Architectural Review and  
Historic Preservation Board  
Agenda Report

File: AR 20-02

RE: Architectural Review 20-02 (Thrive District)  
Blocks B and C. Lots C0, C1, C5, and B10-13 of Meriam Park Subdivision S09-01  
(APNs 002-700-006, -007, -008, -009, 002-180-203, and 002-180-202)

**ARB2**

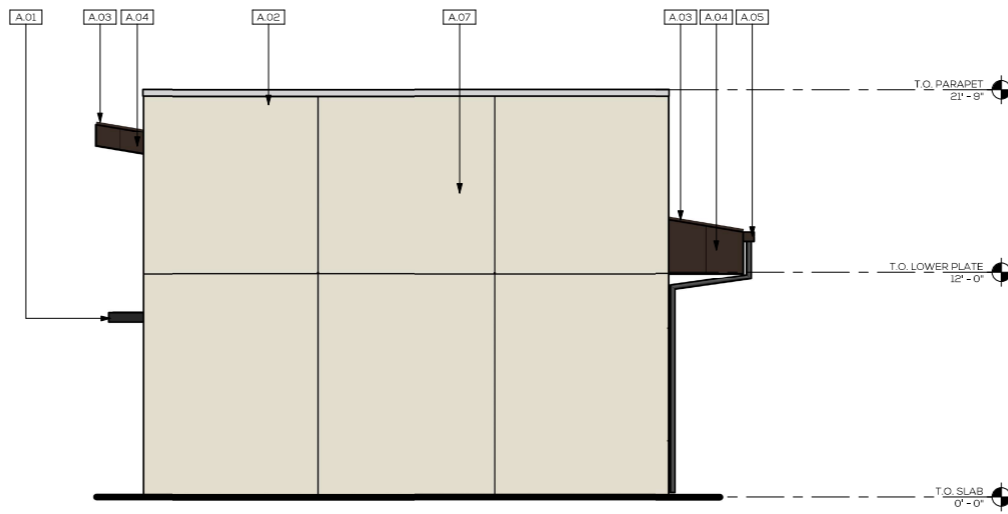
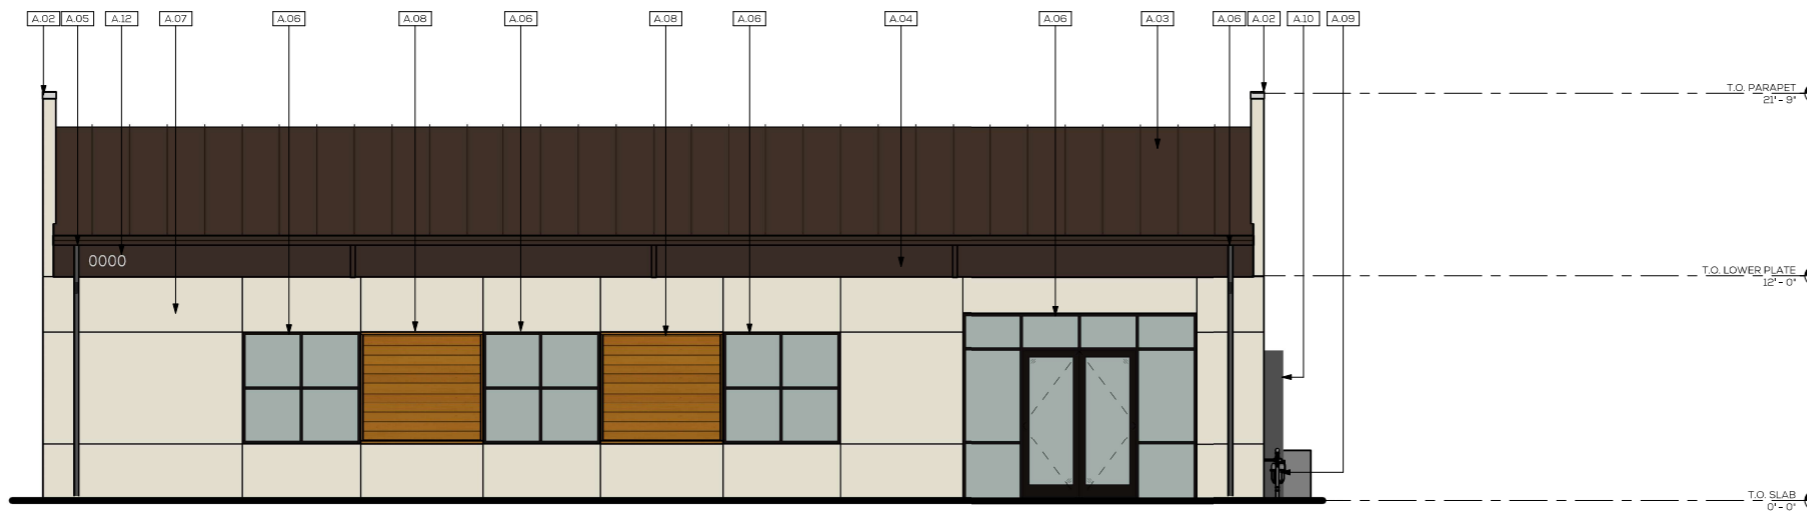
The proposed structures meet City of Chico Design Guidelines (DGs) in a variety of ways. The buildings meet DG 3.2.24 by emphasizing roof design as an integral component of the architecture, and in fact the combined roof and unusual parapet wall present a fascinating design component which brings real architectural interest to the development. The buildings also offer changes in surface materials (DG 3.2.31) and a rich palette of colors, particularly if conditioned to add art (DG 1.3.31), which enhance the streetscape (DG 3.2.32) and create

**ARB2**

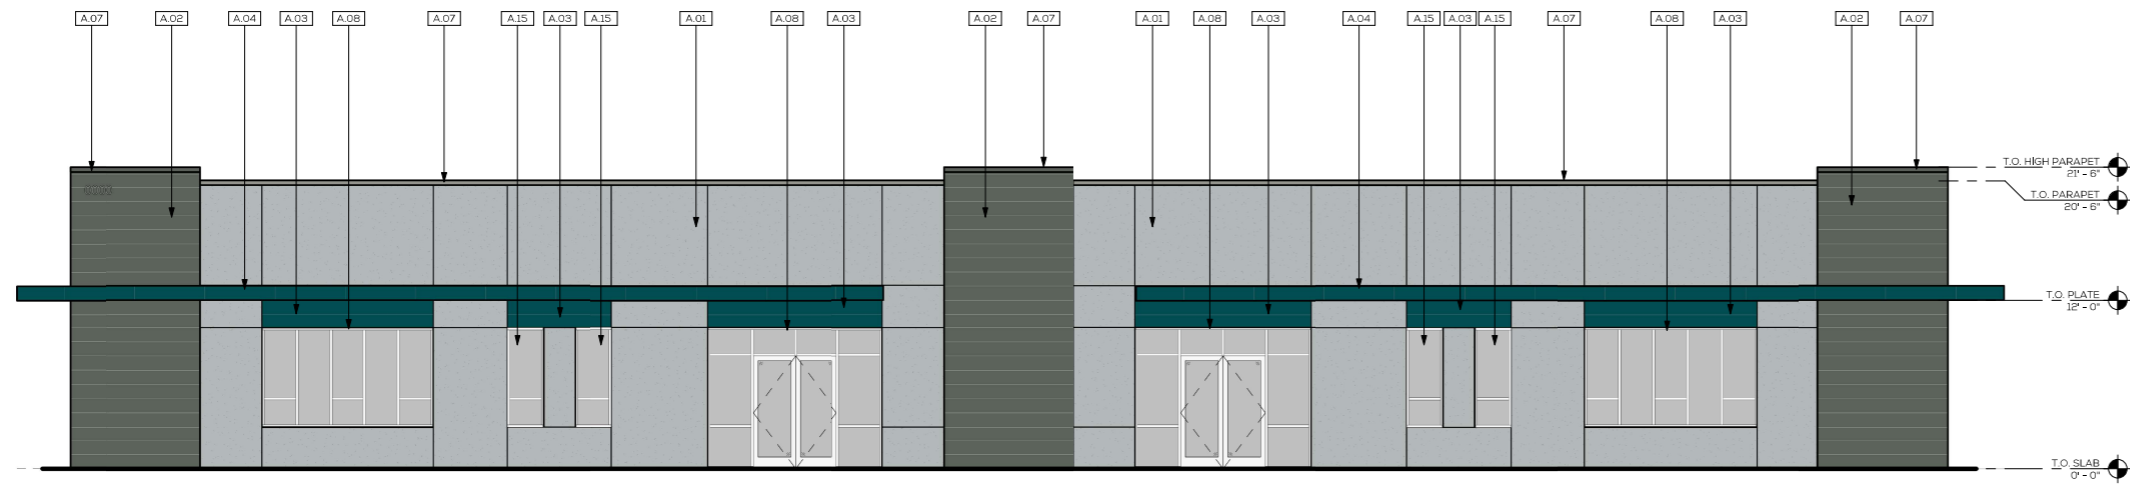
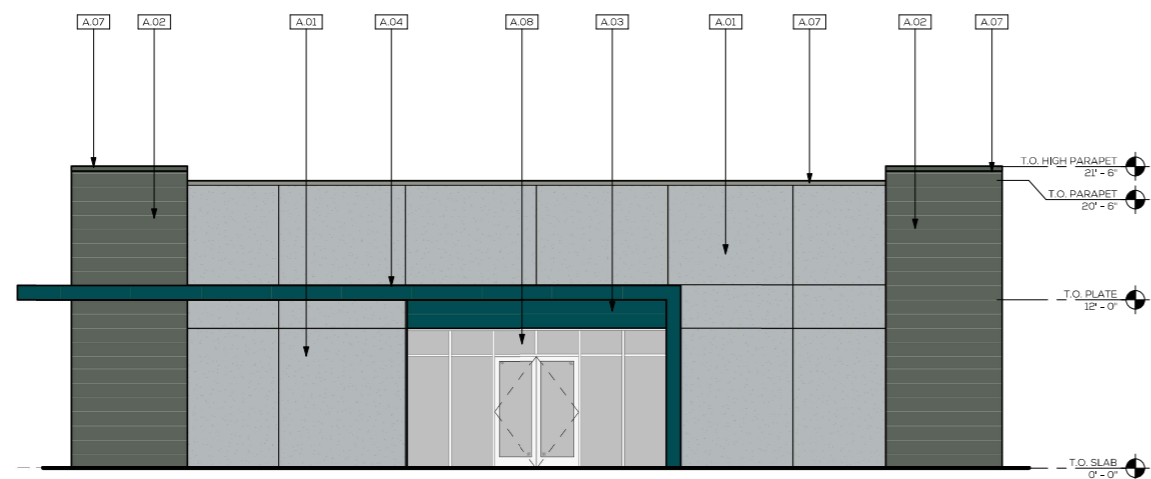
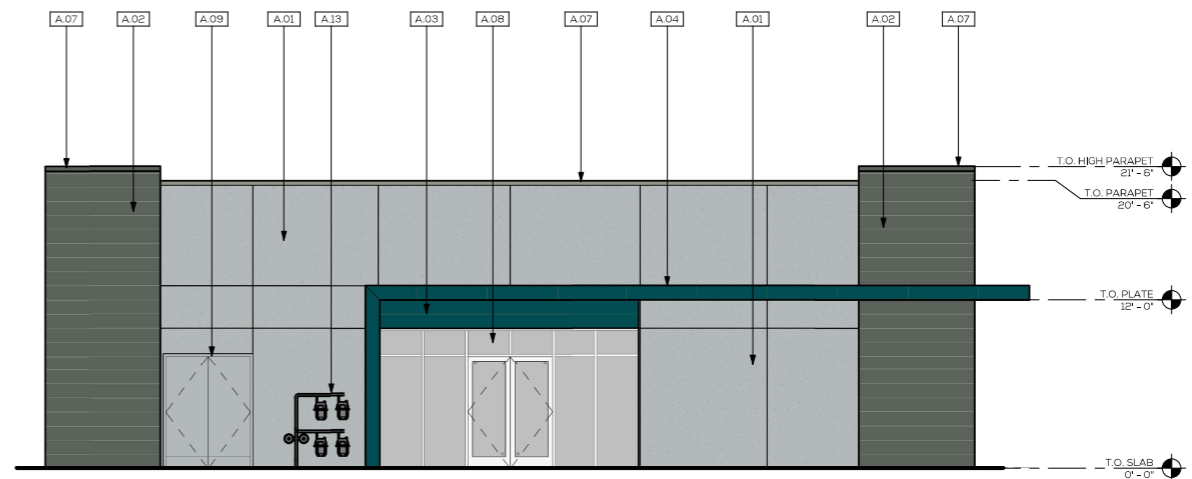
The proposed structures meet City of Chico Design Guidelines (DGs) in a variety of ways. The buildings meet DG 2.2.31 by changing wall materials to add visual interest to the exterior, and DG 2.2.33 by carrying the design through all four elevations in order to provide consistency. The buildings are challenged by Design Guidelines recommending creativity and the avoidance of monotony, but in general they adequately meet the City's requirements.

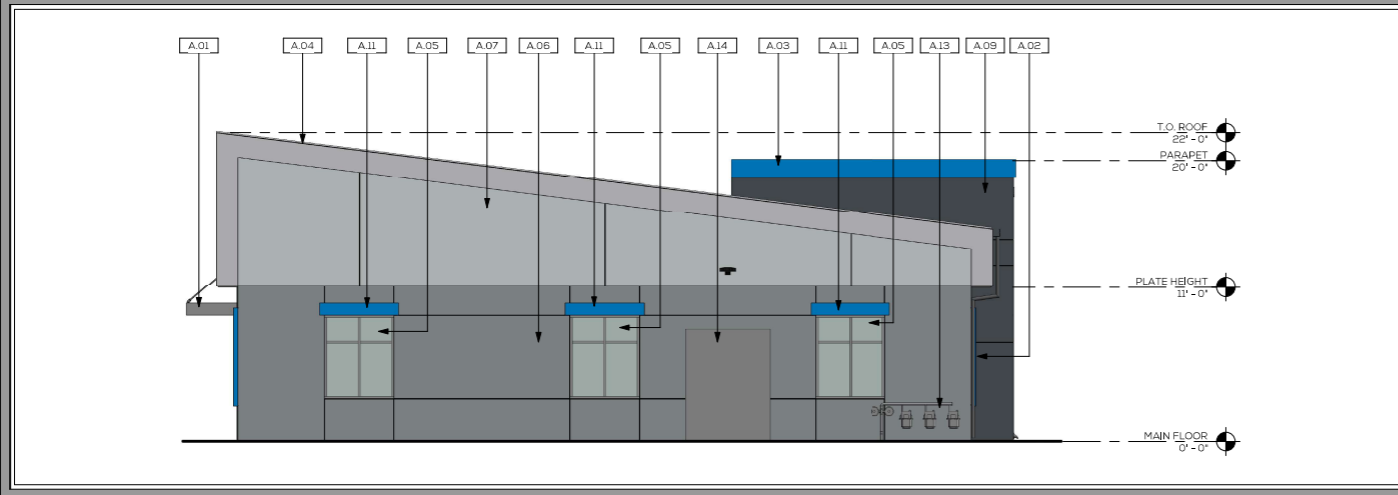
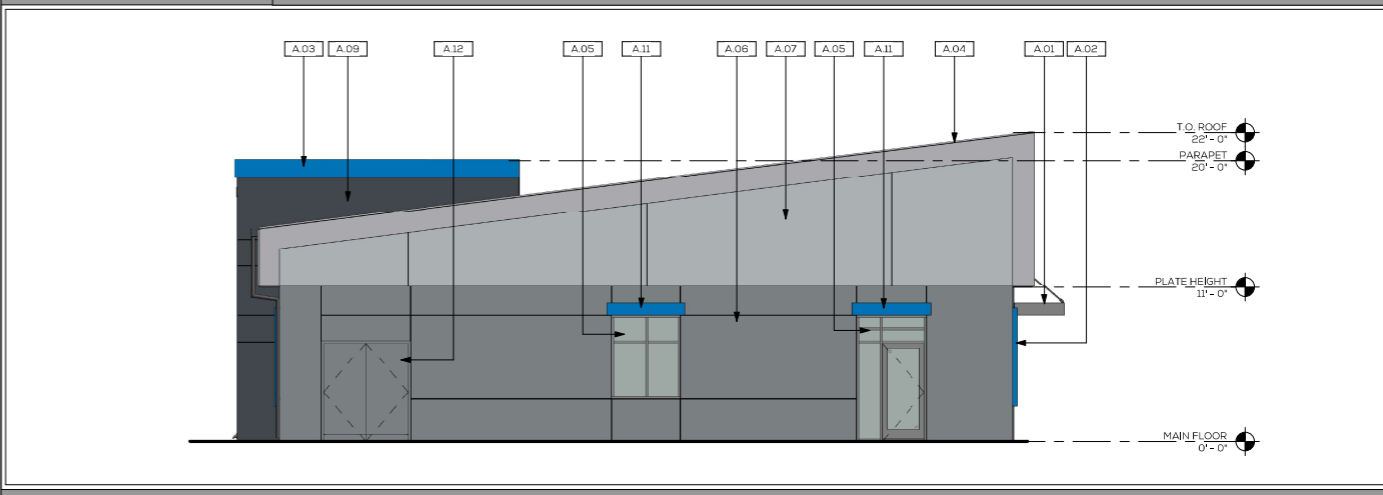
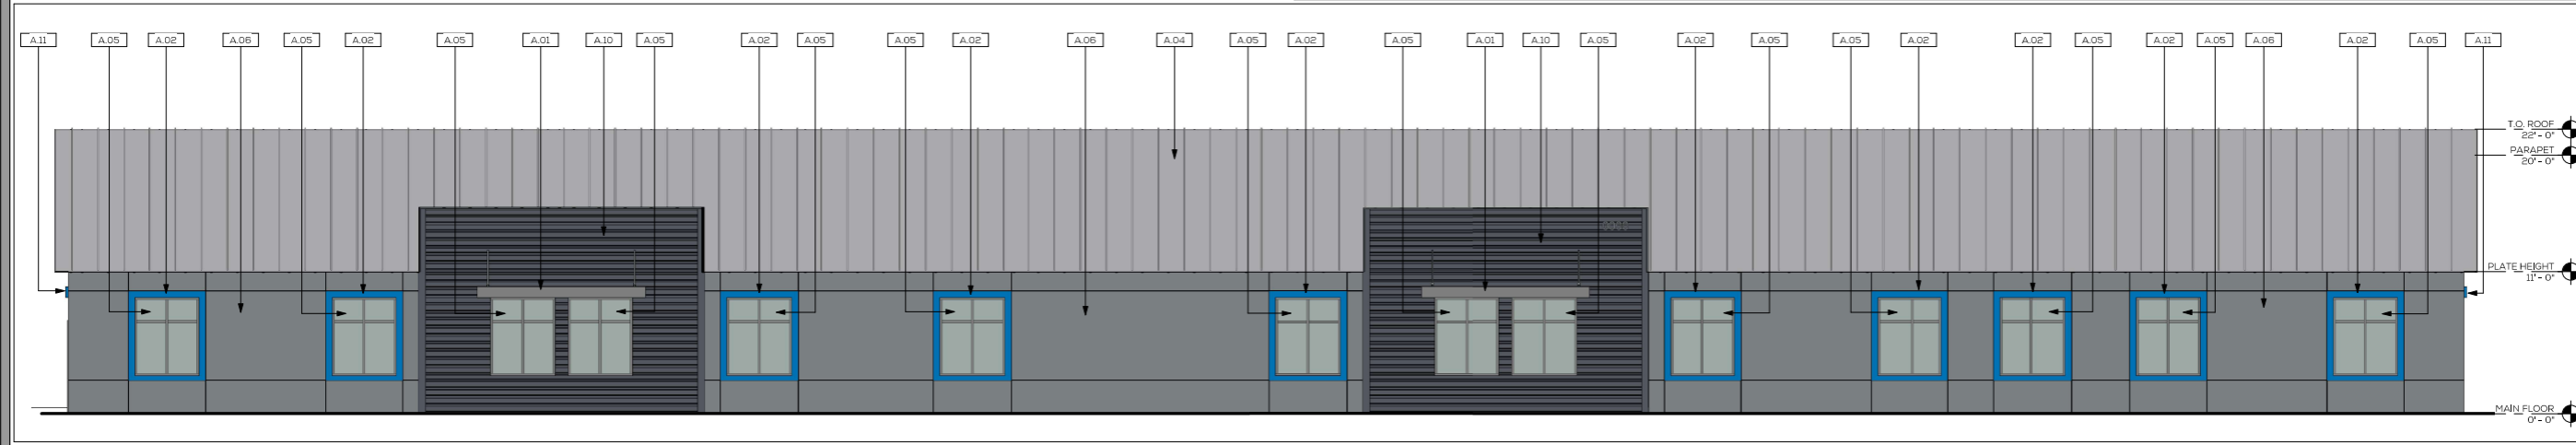
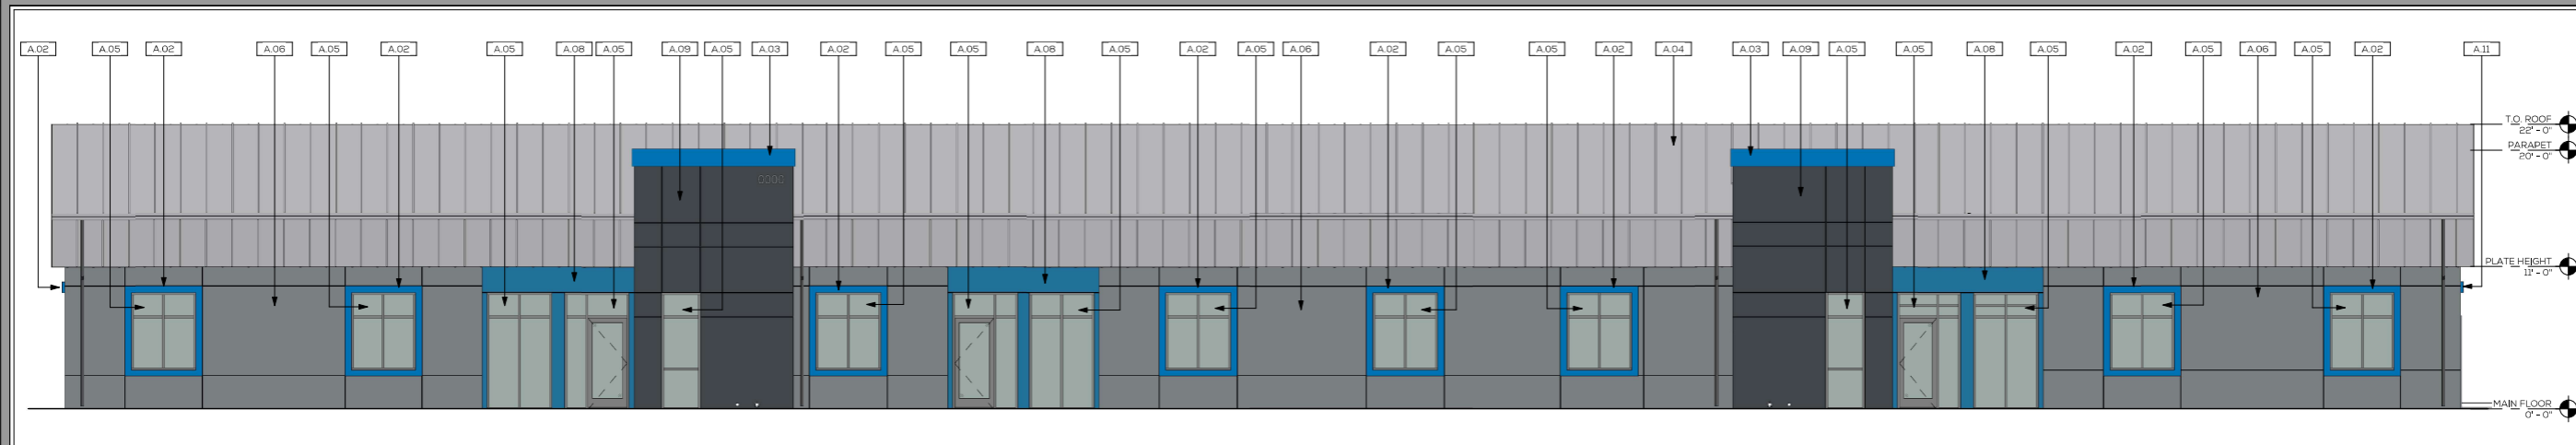
The proposed structure meets City of Chico Design Guidelines (DGs) in a variety of ways. The buildings meet DG 3.2.24 by emphasizing roof design as an integral component of the architecture, and DG 3.2.33 by carrying the design through all four elevations in order to provide consistency. The structure also has varied surface materials (DG 3.2.31) and screens parking areas from street views (DG 3.1.24).
